> **Re:** Case No. 20-417-EL-BGN -In the Matter of the Application of Grover Hill Wind, LLC for a Certificate of Environmental Compatibility and Public Need to Construct a Wind-Powered Electric Generation Facility in Paulding County, Ohio.

Response to Fourth Data Request from Staff of the Ohio Power Siting Board

GROVER HILL WIND, LLC 'S RESPONSE TO THE FOURTH DATA REQUEST FROM THE STAFF OF THE OHIO POWER SITING BOARD

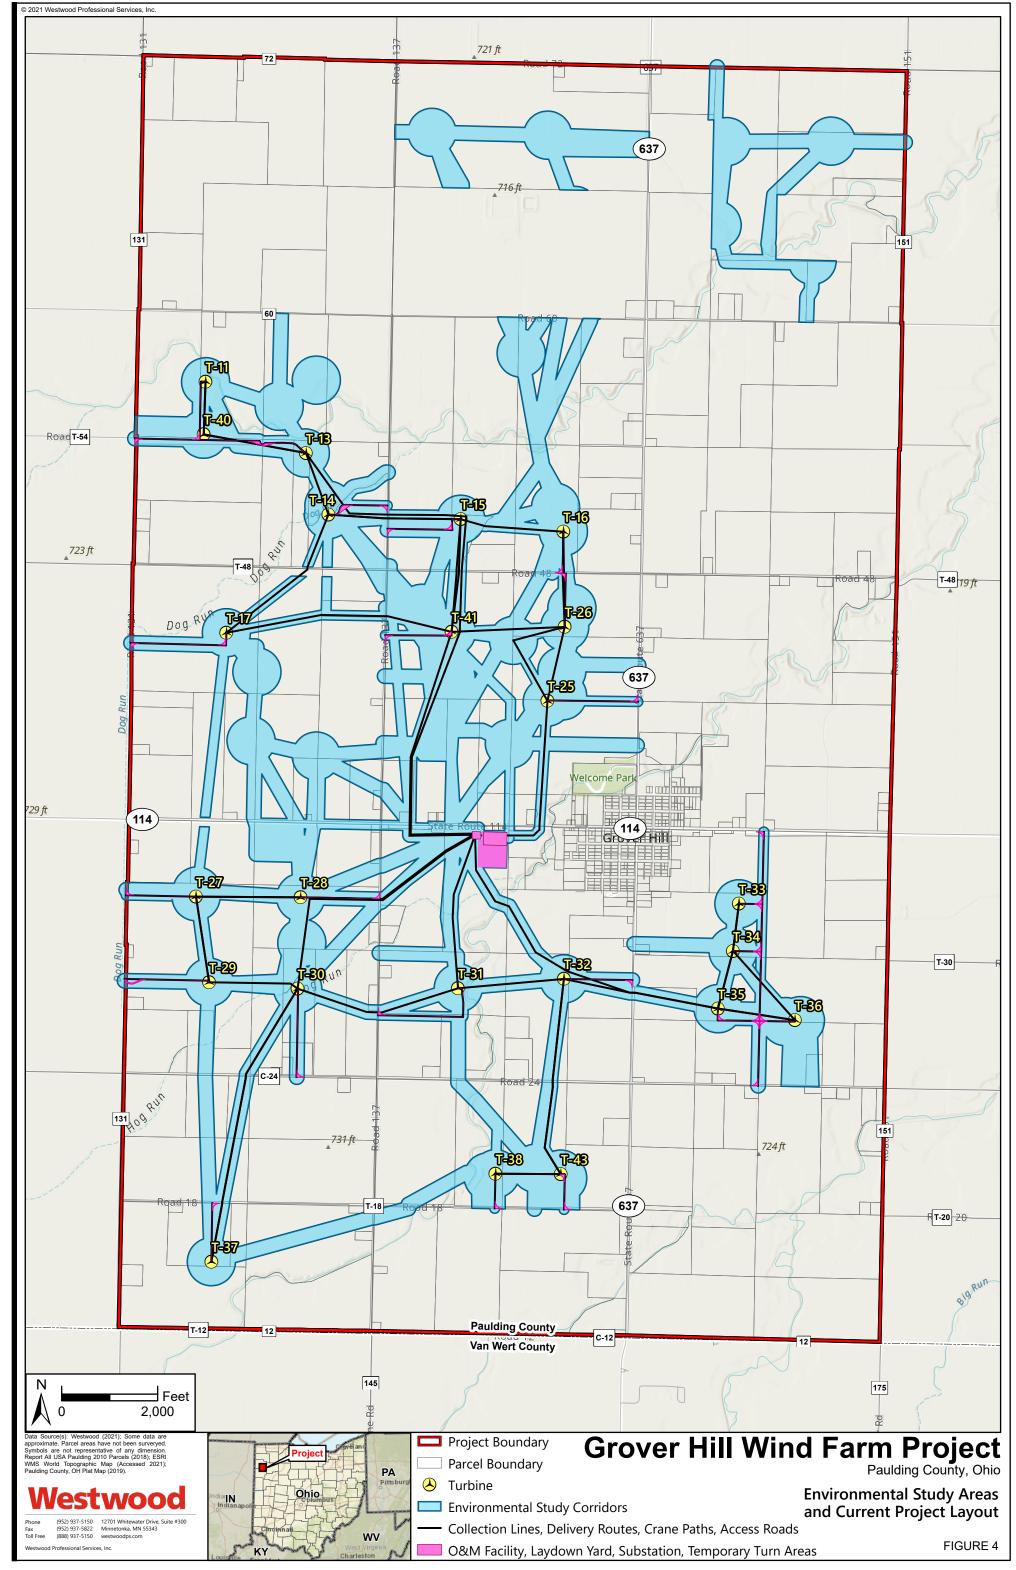
1. Please see attached images for reference. The attached Grover Hill Locations image depicts turbine locations as presented in the application. The OHPO Turbine Location Question image illustrates turbine locations as supplied to the Ohio Historic Preservation Office by the Applicant's cultural resources consultant. (Note: the red turbine location dot in the center does not correspond to the green surveyed area and it does not show a circular-shaped surrounding area of potential effects.) When superimposed, the images' locations do not align. As such, Staff is concerned that this misalignment might lead to incorrect information that could affect the OHPO's review. For the attached images, verify the correct proposed turbine location(s) and provide an illustration of the surrounding cultural resources survey depicting the area of potential effects studied.

2. For the entire proposed project, provide shapefiles and illustrations/maps that depict all areas of potential project disturbance superimposed over studied cultural resources areas of potential effects.

Response: Cultural resource investigations for the Grover Hill Wind Farm were initated in August of 2018 with the compilation of the Background Literature Review. This review included the archival investigation of the Proposed Grover Hill Project Area and a 15-mile surrounding buffer. This report was updated in October of 2019 and was included as Application Exhibit Q that was filed on May 3, 2021.

Archaeological reconnaissance surveys were initiated in June of 2020 and were completed in April of 2021. A report summarizing the results of the archaeological survey was compiled and submitted to State Historic Preservation Office ("SHPO") on May 12, 2021 (SHPO Project No. 2020-PAU-47772 – Phase I Archaeological Investigations for the Grover Hill Wind Farm, Latty Township, Paulding County, Ohio). An architectural reconnaissance survey was initiated in February of 2021. A report summarizing the results of the architectural survey was compiled and submitted to SHPO on April 12, 2021 (SHPO Project No. 2020-PAU-47772 – History/Architecture Reconnaissance Survey for the Grover Hill Wind Farm, Latty Township, Paulding County, Ohio). On June 4, 2021, SHPO issued a letter concurring with the results of both the archaeological and architectural survey results.

Iterative design efforts undertaken both prior to and during the execution of the archaeological survey caused some of the proposed turbine site locations to be either abandoned or altered. If the proposed turbine site was abandoned or altered prior to the initiation of the archaeological survey, no survey was conducted at that location. If the proposed turbine site was abandoned following the completion of the archaeological survey, the surveyed turbine site, and associated infrastructure routes to that abandoned turbine site were included in the final report issued to the SHPO in order to memorialize the archaeological survey, the altered site location, and associated infrastructure routes to that altered turbine site was altered following the same area of potential effect defined for the new location.

In the images provided, the red dots indicate proposed turbine site locations that have been abandoned or altered. Those abandoned prior to the initiation of the archaeological survey were not subject to the survey and are not included in the study area survey corridors presented. Those abandoned or altered following the initiation or completion of the archaeological survey will not be located at a point comparable to the current, proposed turbine sites presented in the Application and do not represent a misalignment but a design iteration that is memorialized in the Project documentation. The study area map provided as Figure 4 in the Application presents a comprehensive image of all areas of potential effects that have been physically investigated during on-site archaeological reconnaissance survey. This includes all of the area of potential effect defined for the current turbine array design and areas surveyed in support of previously but now abandoned segments of the Project.

<u>Response</u>: Attached please find Attachment A that provides the illustrations and maps. The Application has also provided the shapefiles to OPSB Staff.
